City of San Antonio

Department of Development Services

Re: **Friesenhahn** **MDP # 802-C**

FRIESENHAHN
MASTER DEVELOPMENT PLAN

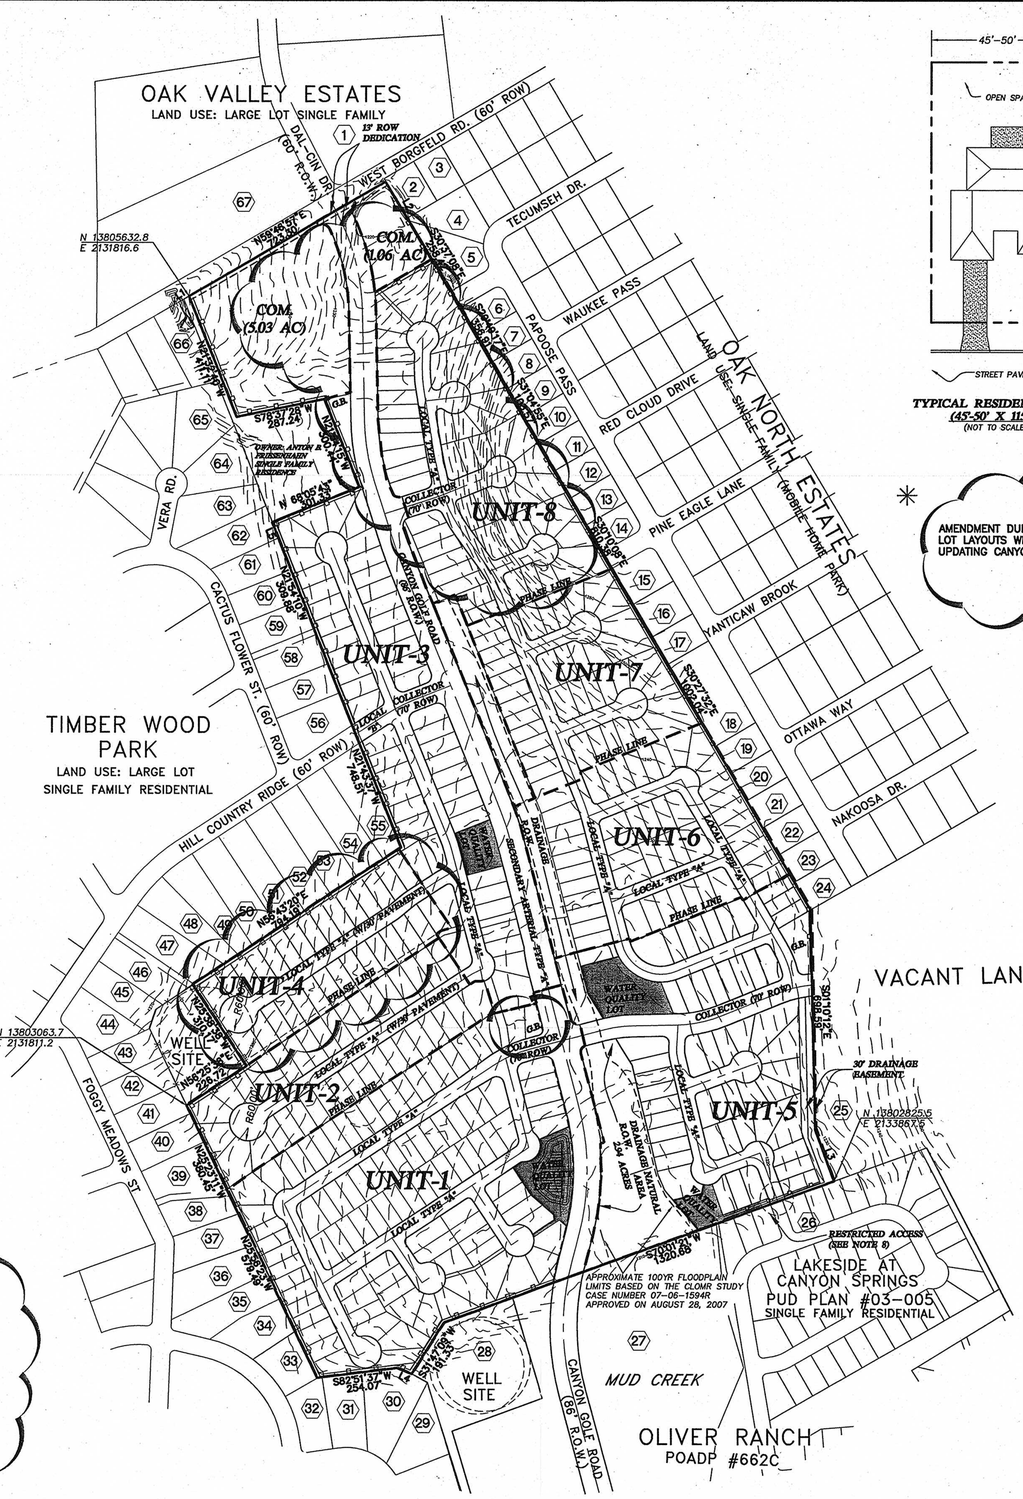
Traffic Impact Analysis and Streets Division approves with the following conditions:

The following on-site improvements, as well as improvements along the project limits are necessary and shall be provided by the developer at the time of platting of the Friesenhahn Subdivision, at no cost to the City of San Antonio:

- Construction of an internal collector street system approximately 800 feet in length.
- The developer shall be responsible for upgrading the intersection of West Borgfeld Road and Canyon Golf Road. Design and construction shall be coordinated with Bexar County.
- All proposed median openings on Canyon Golf Road shall provide sufficient left-turn storage.
- It is recommended that at the intersection of Canyon Golf Road and Proposed Collector that a right turn deceleration lane is provided for the northbound Canyon Golf to eastbound Collector.

Parks and Recreation Department approves with the following condition:

- The fee-in-lieu of parkland dedication must be paid prior to recordation of the first plat associated with this Master Development Plan.

Bexar County approves with the following condition:

The following improvements must be provided by the developer prior to completion of the project:

- Traffic controls shall be placed according to the standards of the Texas Manual of Uniform Traffic Control Devices as warranted and must be approved by Bexar County.
- Voluntary efforts, beyond those herein required, to mitigate traffic impacts are encouraged as a means of providing enhanced traffic and pedestrian capabilities to users of the development as well as others.
